RE. The Northern Road Upgrade Stage 5
Consistency Assessment – Construction Boundary Review
Aboriginal Heritage

Kelleher Nightingale Consulting has reviewed The Northern Road Upgrade Stage 5 (TNR5) footprint (Figures 1-5) (TNR5 Consistency Assessment Construction Boundary) in reference to proposed boundary adjustments and the Environmental Impact Statement (EIS) related to the Aboriginal heritage assessment detailed in *The Northern Road Upgrade between Mersey Road, Bringelly and Glenmore Parkway, Glenmore Park Aboriginal Cultural Heritage Assessment Report* (May 2017 v10).

Figure 3. TNR5 – Consistency Assessment Construction Boundary review

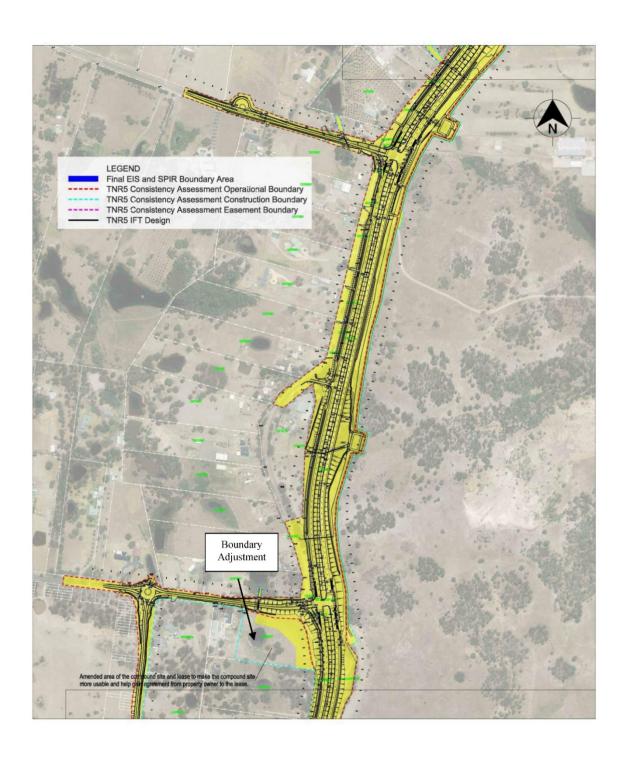
Three locations were identified where the TNR5 construction boundary has changed slightly since the finalisation of the EIS (shown as Boundary Adjustment on Figure 3, Figure 4 and Figure 5).

No Aboriginal objects/sites were identified in the three locations.

The three locations are consistent with the findings of The Northern Road Upgrade cultural heritage assessment report (as per the EIS).

No further Aboriginal archaeological assessment is warranted.
